# **CITY PLANNING COMMISSION AGENDA**

**THURSDAY, JULY 16, 2015  
8:30 A.M.**

## CITY PLANNING COMMISSION MEETING AGENDA THURSDAY, JULY 16, 2015

**FIGURE 9**

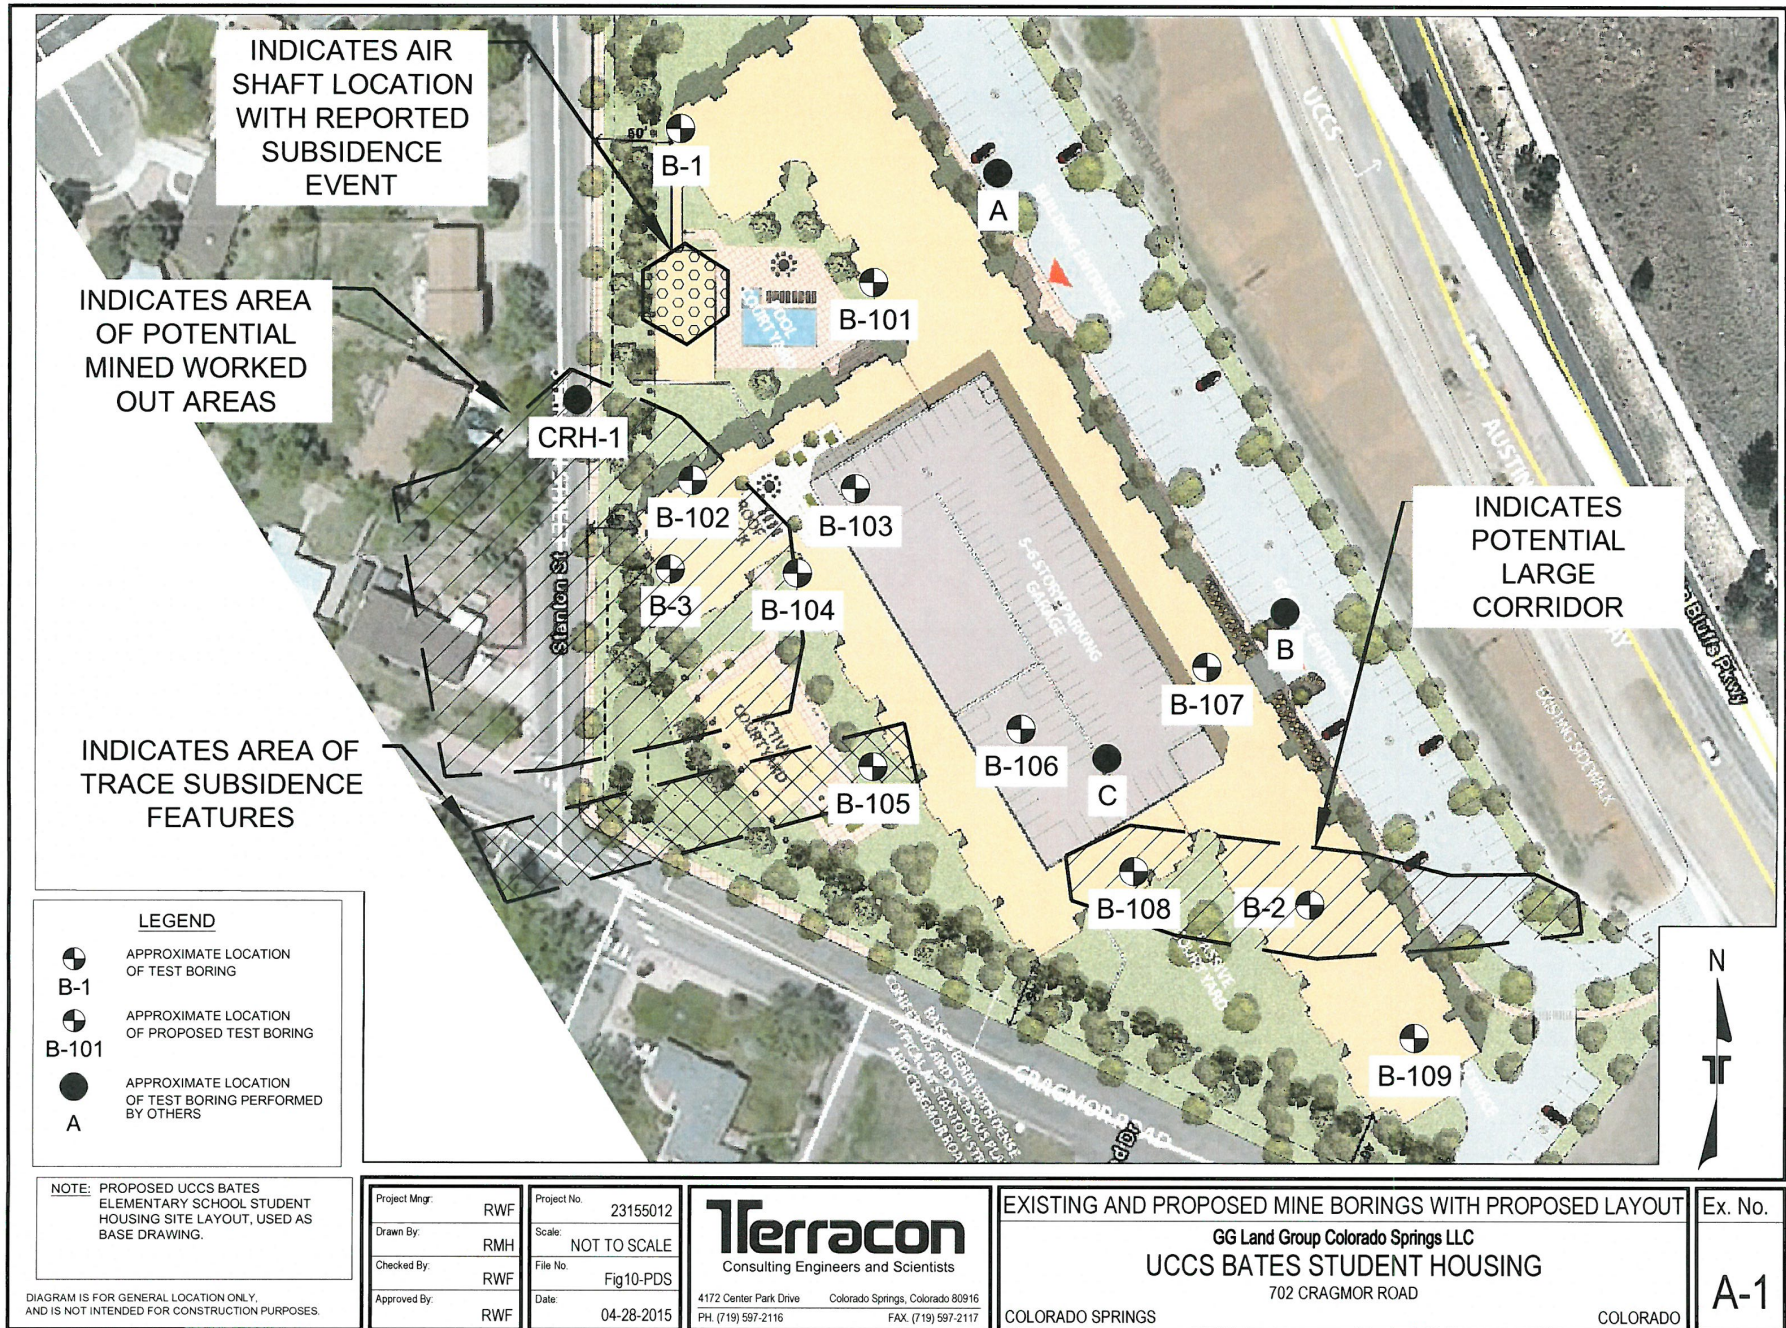
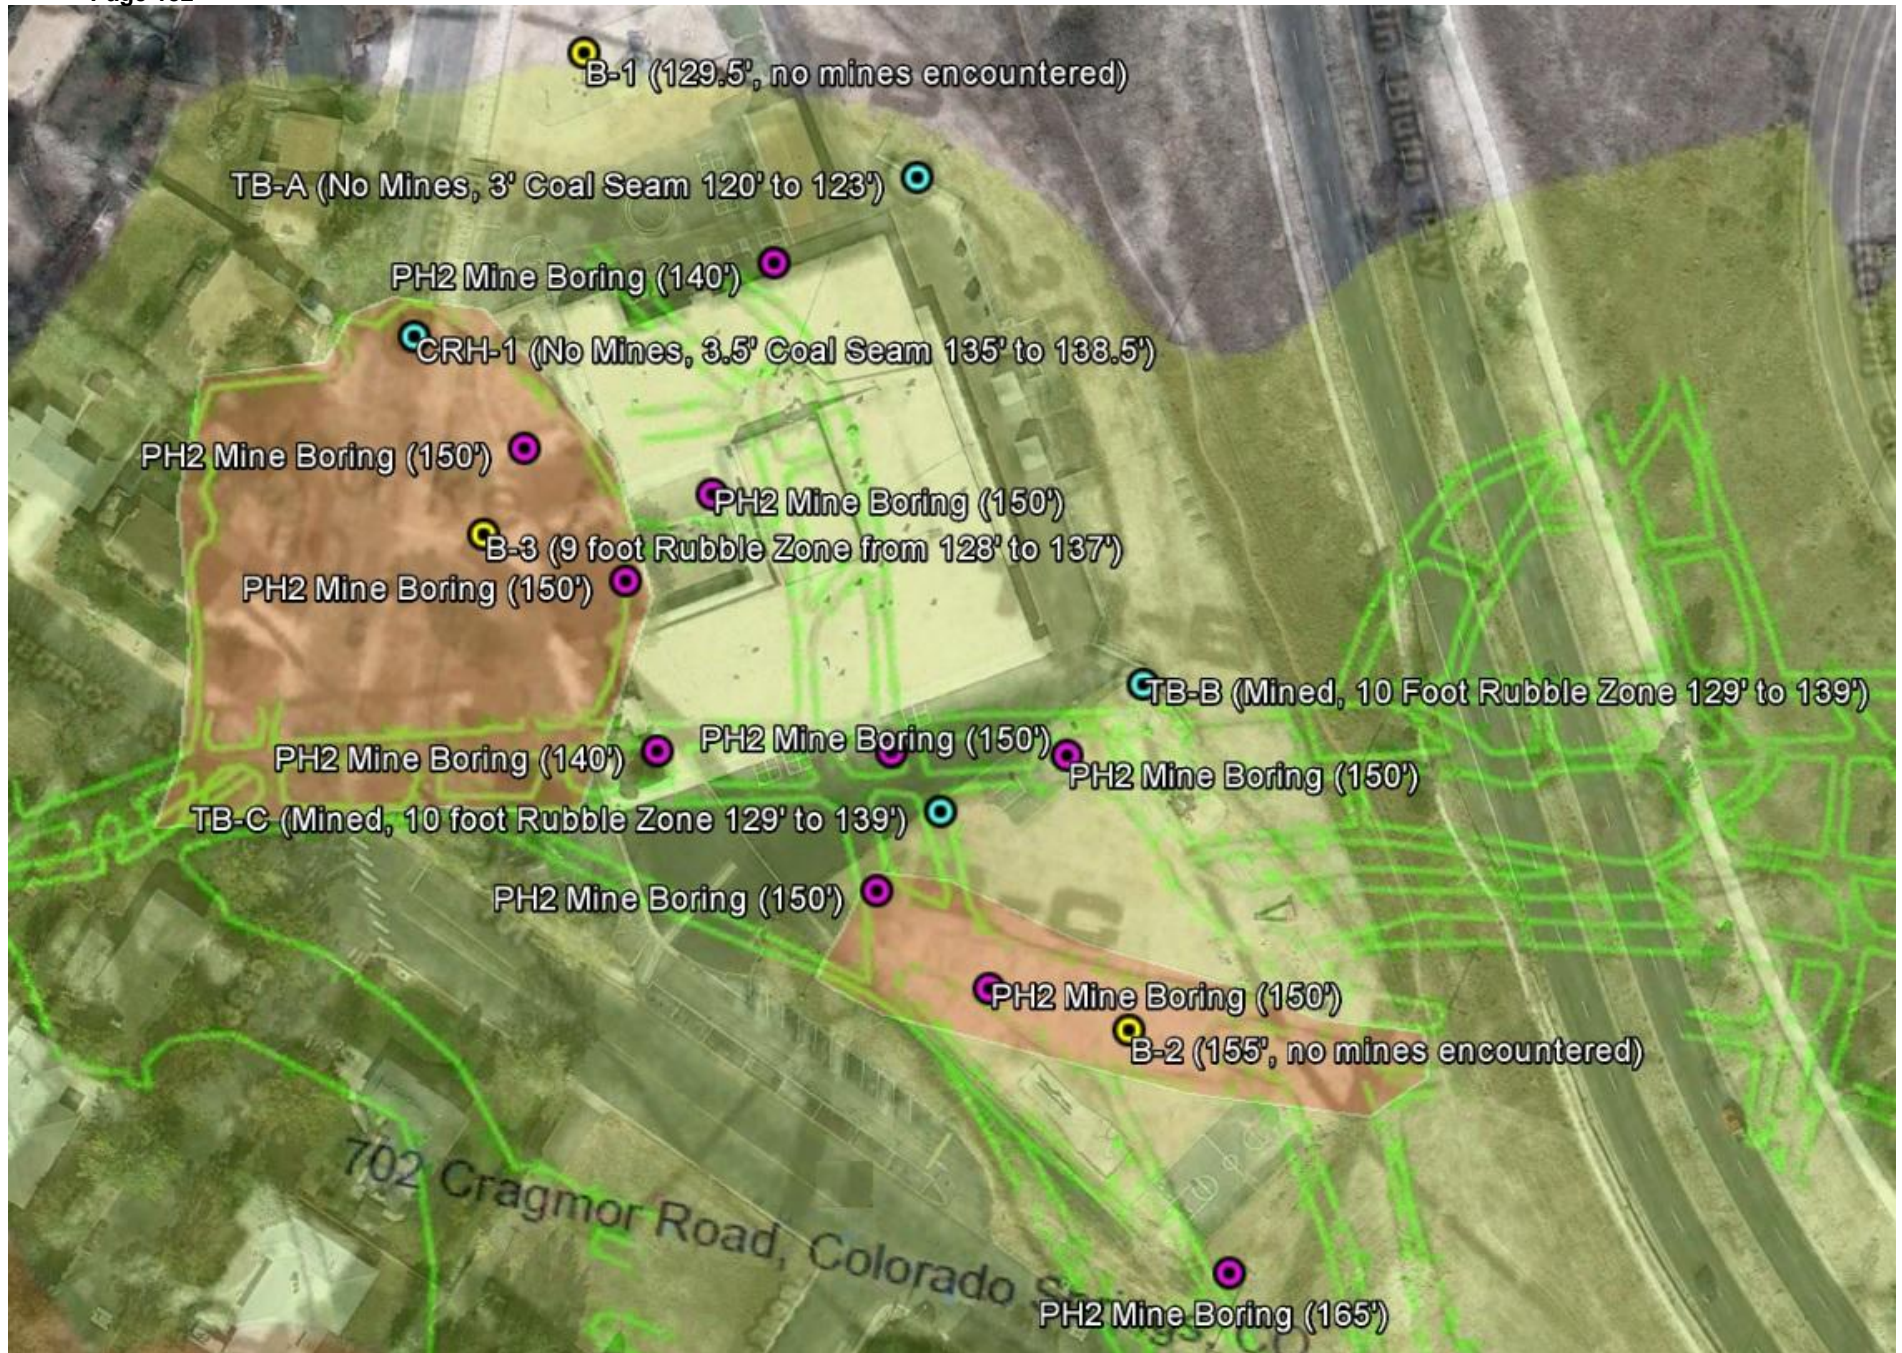
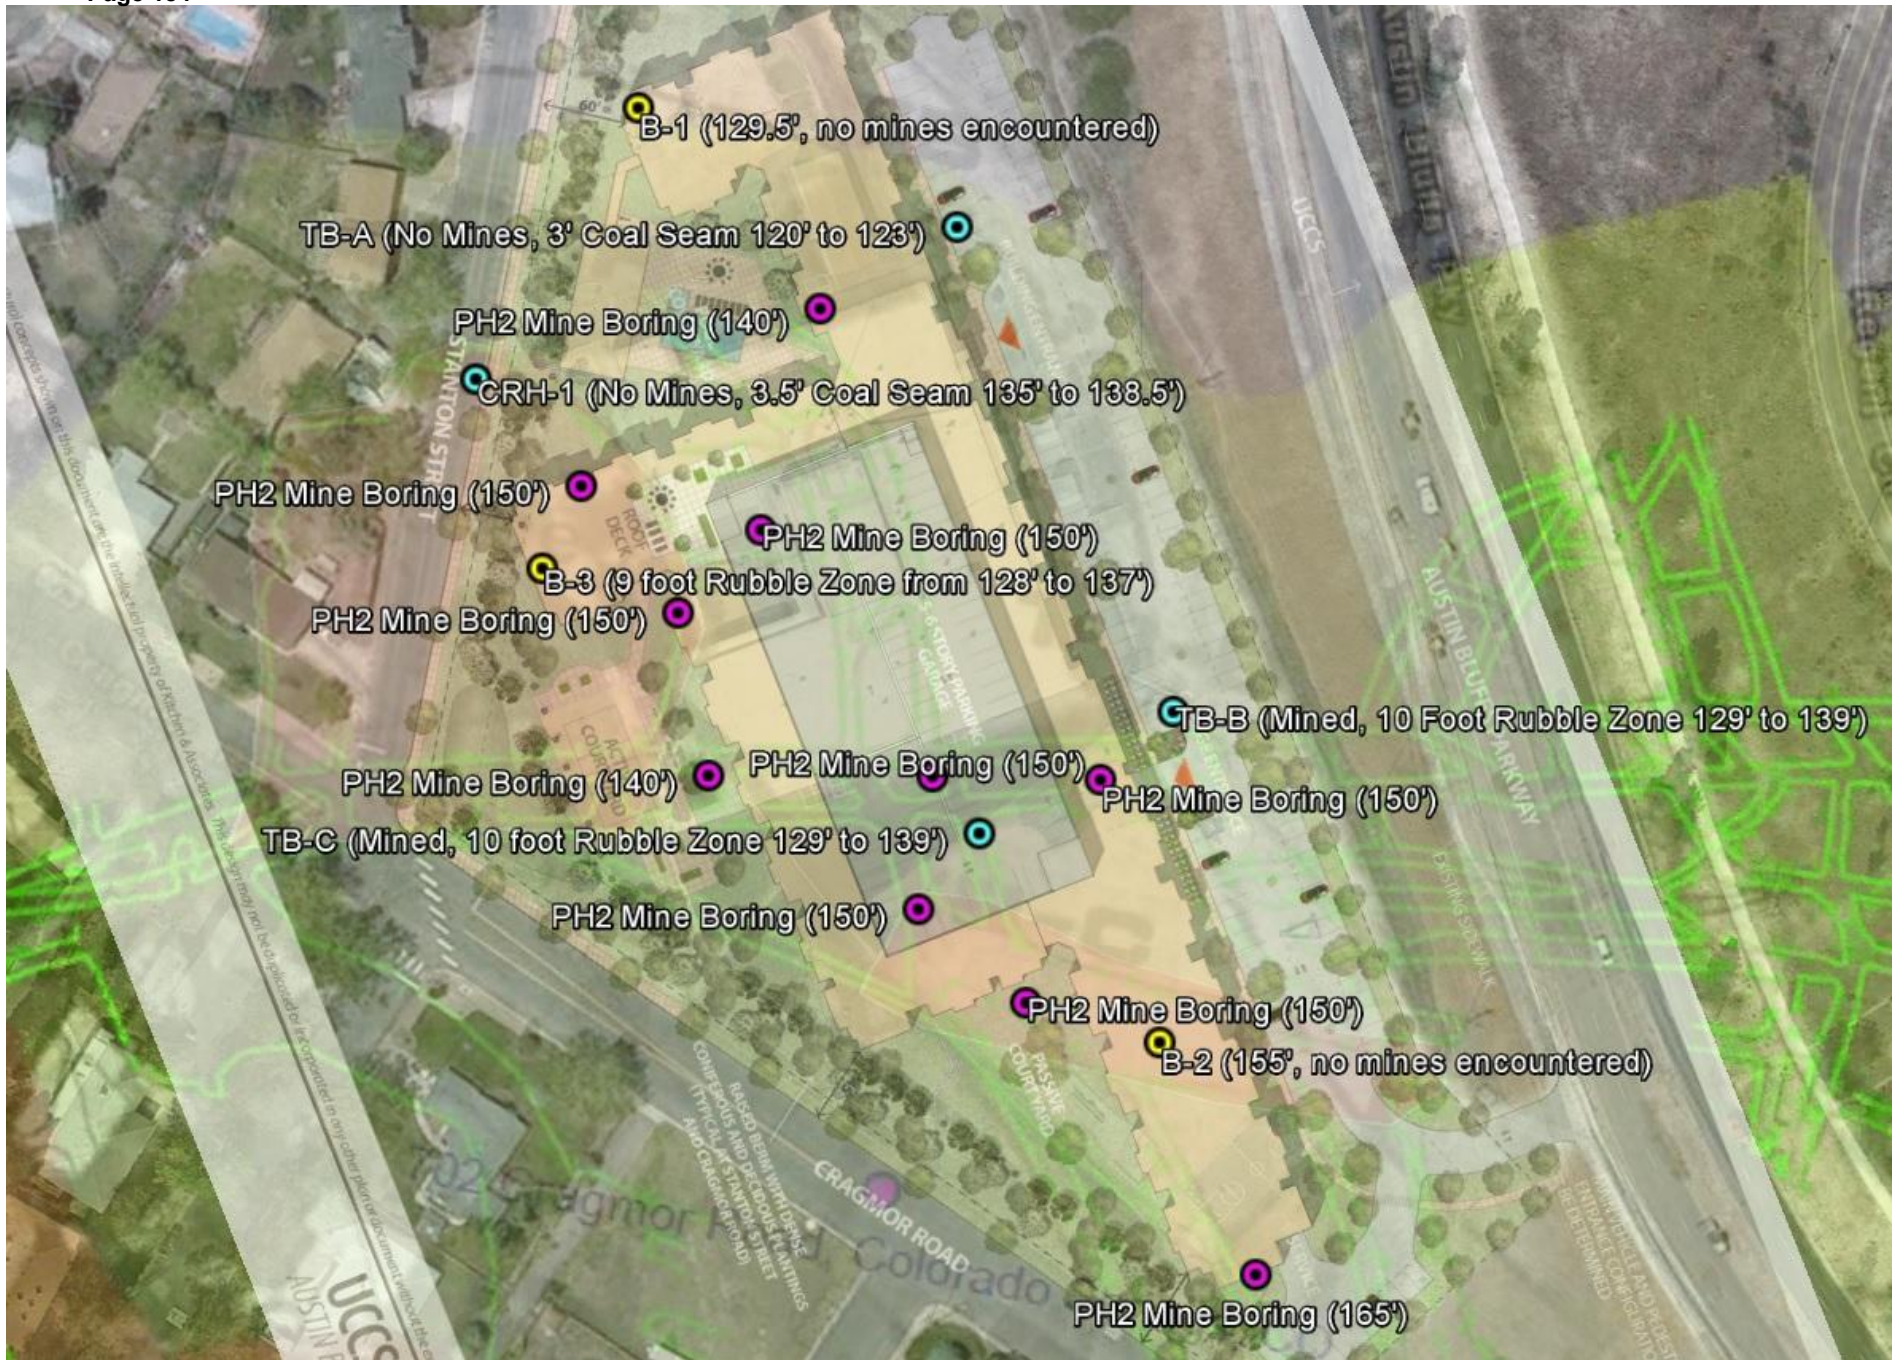
We encountered a relatively soft zone within the bedrock profile at a depth of about 110 to 115 feet below the ground surface within Test Boring B-1. The rock cored unusually fast (approximately 2 minutes) for the 5-foot core run. We recognized this as an area of concern, however, a review of the gamma, caliper, and density logging within this boring did not indicate this zone was associated with features commonly found with mining activity. Therefore, it is our opinion that the zone from 110 to 115 feet below the ground surface within Boring B-1 is associated with a layer of lower strength bedrock, not mining activity.
